Subject: **Response to NRC RAI Letter No. 363 Related to ESBWR Design Certification Application – DCD Tier 2 Section 3.8 – Seismic Category I Structures; RAI Number 3.8-94 S05**

ENCLOSURE 1

**Response to NRC RAI Letter No. 363
Related to ESBWR Design Certification Application¹**

RAI Number 3.8-94 S05

Figure 3.8-94(1) Input Motion Spectra and RFB SSI Fundamental Frequencies

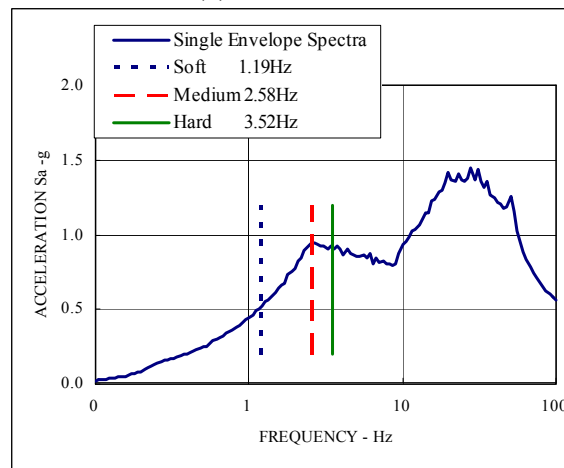
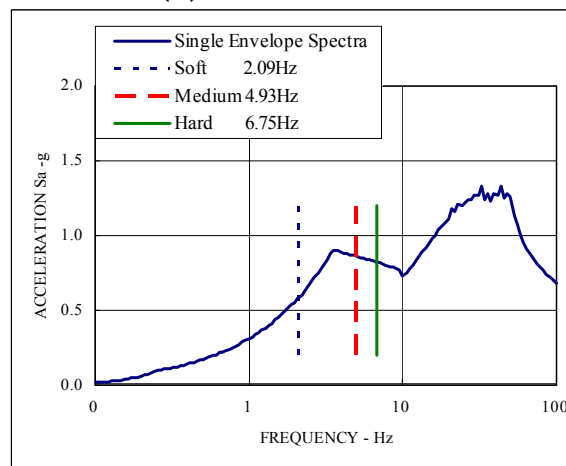
- (2) GEH is requested to explain why it is acceptable to use a linearly interpolated value for the soil bearing capacities between the three sets of values (soft, medium, and hard). Using the information presented in Figure 3.8-94(1) (c) of the response (as an example), this would underpredict the required bearing capacity.*

In accordance with NRC RAI 3.8-94, Supplement 2, Figure 3.8-94(1) (c), the vertical input response spectrum peaks at 3.57 Hz in the frequency range between 2.09 Hz for the soft site and 4.93 Hz for the medium site. This peak vertical frequency is 73% of the vertical SSI fundamental frequency at the medium site.

Figure 3.8-94(19) FRS (Compared with the DAC3N) – RSW Top Y

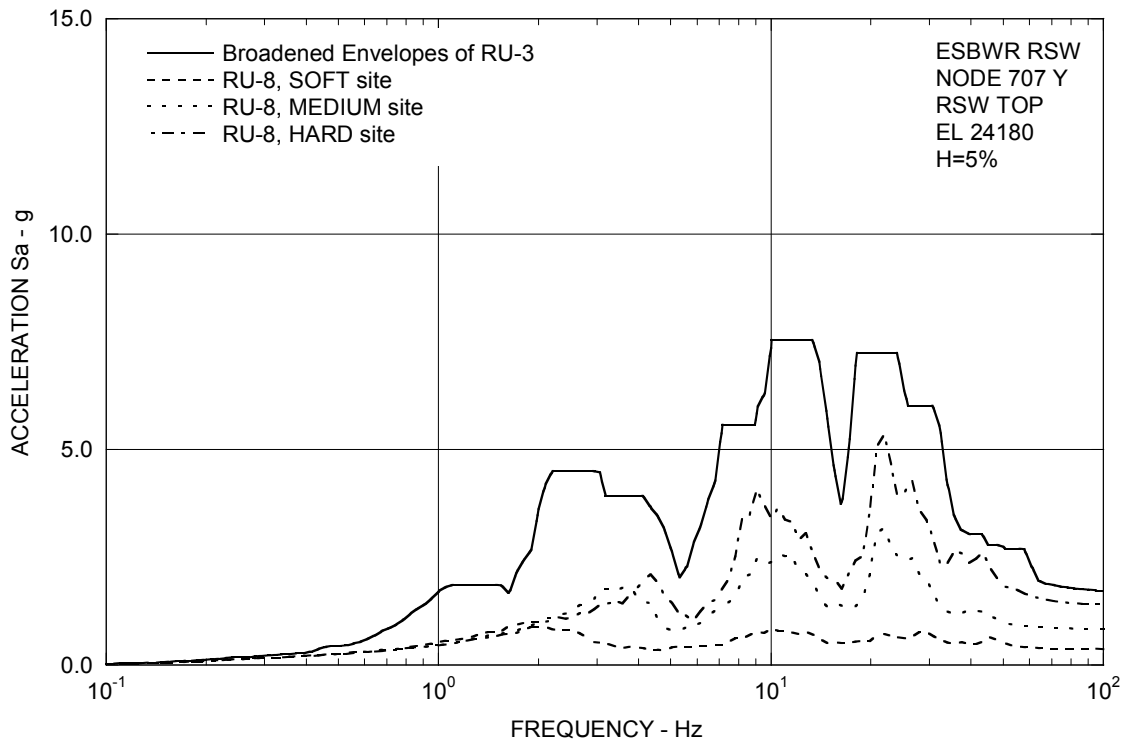
- I) *In several of the enveloping floor response spectra (e.g., Figures 3.8-94(19), (20), and (22), the staff noted that “valleys” exist between successive peaks in the low frequency region, up to approximately 5 Hz. If the spectral peaks are influenced by site conditions, it is the staff’s position that these “valleys” should be filled-in to accommodate the expected variability in site shear wave profiles that may be encountered for this generic design. GEH is requested to provide an explanation why these valleys have not been filled-in.*

- I) Sufficient levels of conservatism are already built into the design floor response spectra in the form of enveloping and peak broadening the results of a sufficient number of generic sites under a bounding Certified Seismic Design Response Spectra (CSDRS) ground input motion. To provide additional margins for sites that might have predominant SSI frequencies at the spectral valleys, the spectral valleys of the site enveloping floor response spectra are further filled-in for the generic design floor response spectra. As an example, the original enveloping floor response spectra at the Vent Wall top, which is the same location as shown in Figure 3.8-94(18), is shown in Figure 3.8-94(43) together with its respective enveloping floor response spectra having the spectral valleys filled-in. The site enveloping floor response spectra in DCD Tier 2 Subsection 3A.9.2 will be replaced in Revision 6 with enveloping floor response spectra having the spectral valleys filled-in. DCD Tier 2 Subsections 3A.8.7 and 3A.9.2 will be revised in Revision 6 for clarification with regards to the spectral valleys being filled-in.

Figure 3.8-94(40) RB/FB Layered Site Soil Case RL-2, Time = 7.810 sec

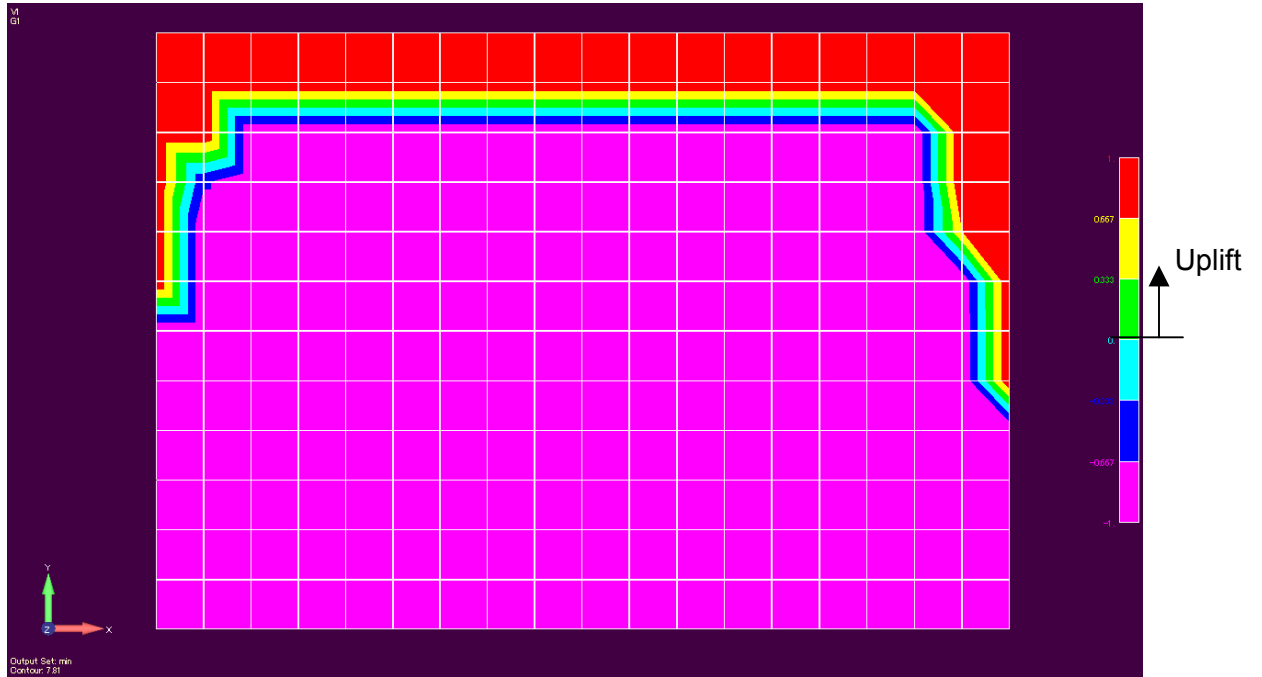
- C) *The forces used to calculate the maximum soil bearing pressures were obtained from the SASSI analyses. These analyses consider that the soil and foundation are integrally connected. However, the bearing pressure calculations on page 11 of 34 show that uplift occurs. Describe the extent of the maximum uplift that occurs in SASSI (denoted by tension in the soil springs), recognizing that this region could expand further if the tension springs would be released using a different computer code. Provide the technical basis for using these seismic loads in the bearing and sliding calculations from the SASSI analyses without consideration of the effects of uplift on the seismic demand loadings. Alternatively, an analysis that considers the nonlinear effect of liftoff due to the three input directions applied simultaneously can be considered.*

Lastly, provide the magnitude of the uplift calculated using the EBM so that a comparison can be made with the extent of implied uplift (i.e., tensile basemat/soil interface loads) shown in Figure 3.8-94(40) of the RAI response. The above requested

The SASSI results for the RB/FB layered site soil Case RL-2 are examined for the extent of maximum uplift when the bearing pressure reaches maximum in combination with dead loads and buoyancy. As shown in Figure 3.8-94(40), the extent of uplift is not extensive and a large portion of the basemat remains in contact with the soil.

Figure 3.8-94(44) Basemat Configuration and Pressure Distribution

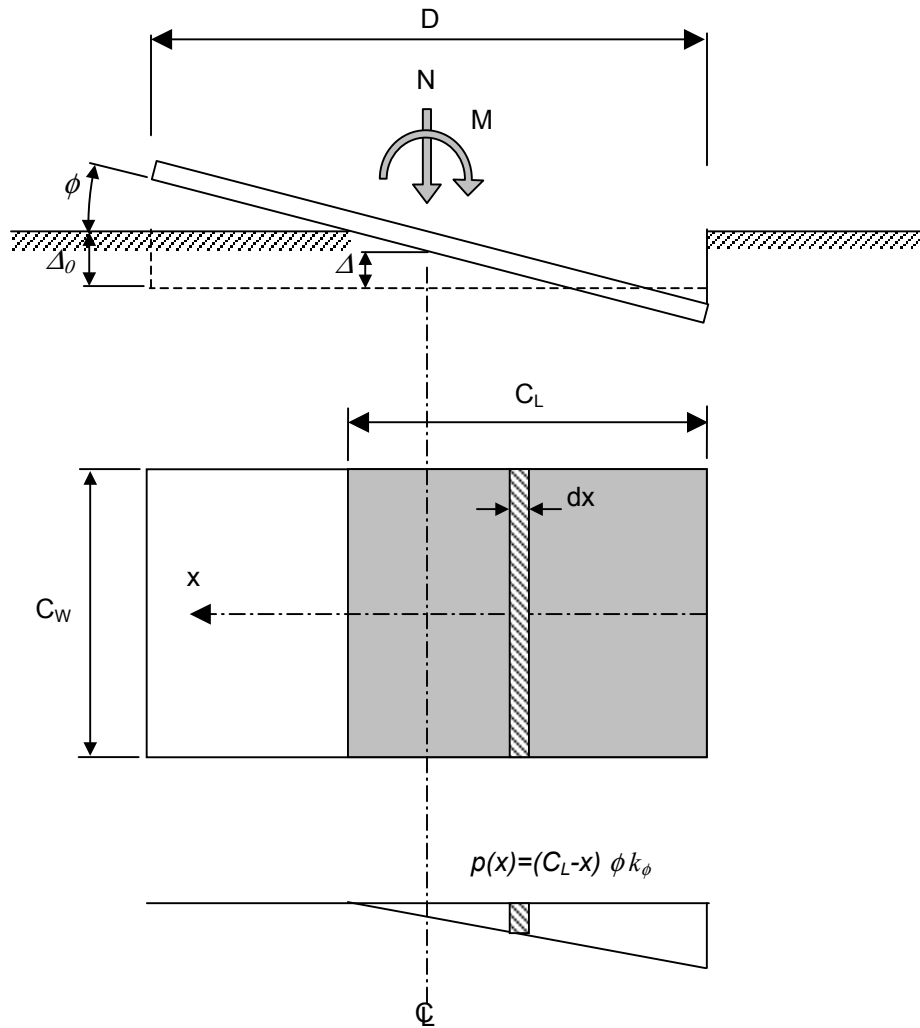
- 1. The formulation presented in the referenced paper is applicable to circular rigid foundations. Provide justification for use of these formulations for the rectangular foundations for ESBWR. Otherwise, if a new set of formulations were derived for the rectangular foundations at ESBWR, provide the basis for these new formulations.*

Figure 3.8-94(44) shows the configuration of a rigid rectangular basemat in the uplifted position. The basemat is considered to be supported by a set of uniformly distributed compression (no tension) vertical soil springs having stiffness k_ϕ per unit area, which are determined by the following:

Referring to Figure 3.8-94(44), the foundation vertical force N and the overturning moment M in the uplifted position can be related to soil pressure $p(x)$ and the foundation contact length C_L .

Figure 3.8-94(46) Soil Pressures due to Moments in Two Directions

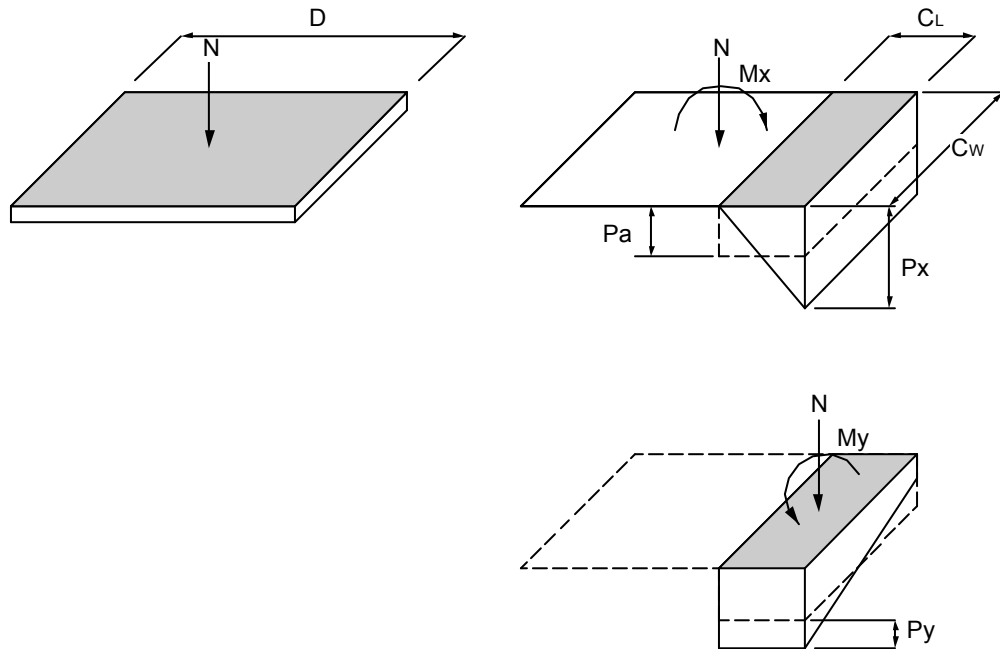
- 3. Confirm that the "Contact Width – CW" used in the formulations for bending about the other (perpendicular) horizontal axis corresponds to the full width of the foundation. If this is the case, then explain why the full width is utilized. Has it been determined that no uplift is possible for rotation about the other horizontal axis or that the uplift about both axes do not occur at the same time? The staff notes that if there is uplift possible for rotation about the other horizontal axis, this might cause higher soil bearing pressures than those calculated in the RAI response.*

- (3) To account for potential uplift due to rotation about the other horizontal axis, two separate cases, a) M_x using MEB together with M_y with full width C_W and b) M_y using MEB together with M_x with full width C_W , were considered as illustrated Figure 3.8-94(46). The final soil bearing pressure is the envelope results of the two cases.
